CITY OF MADISON
Common Council
INTER-DEPARTMENTAL
CORRESPONDENCE
210 Martin Luther King, Jr. Blvd., Rm. 417
266-4071

DATE: July 9, 2007

FROM: Ald. Julia Kerr, District 13

SUBJECT: **Fieldhouse Station Comments**

Figure 3

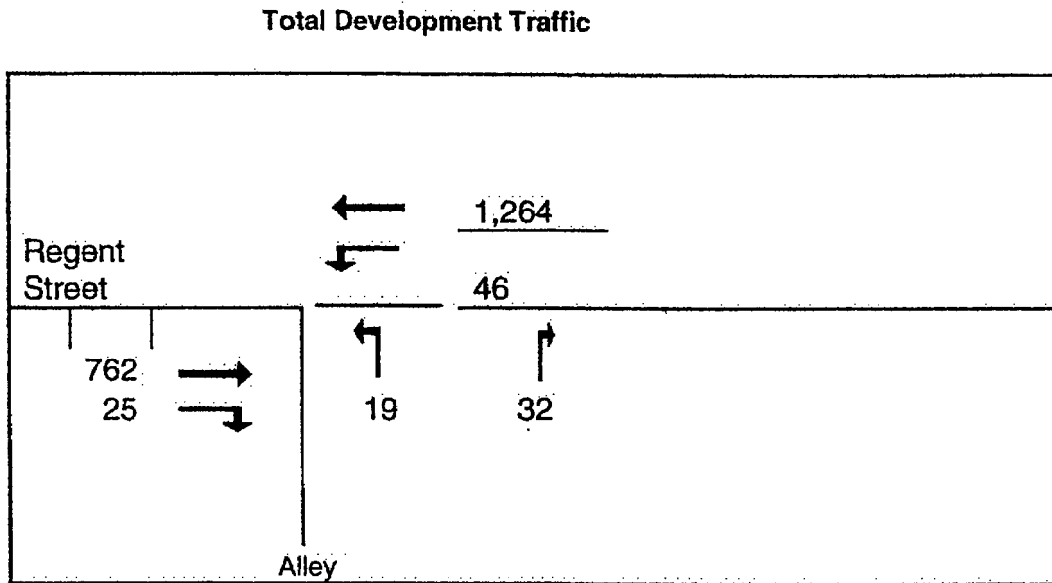
First, beyond the very poor level of service for the estimated 19 cars exiting the alley during the peak period and wanting to take a left to head west, the study does not discuss the effect of the estimated 46 west-bound cars per peak hour essentially seeking to make the reverse movement and turn across the east-bound lanes and into the alley (See Attachment II). These cars will have to stop in one of the two west-bound Regent Street lanes and wait for an opening in the east-bound traffic in order to execute the turn. I would hope that the Plan Commission will consider the effect on nearby businesses as well as other property owners that will result from the increased congestion at this important intersection directly attributable to this project.

Second, the study does not address if the 20 foot reconfigured alley will give drivers turning into the alley sufficient radii to execute the turn off the street when there is a car waiting in the alley to turn onto Regent Street.
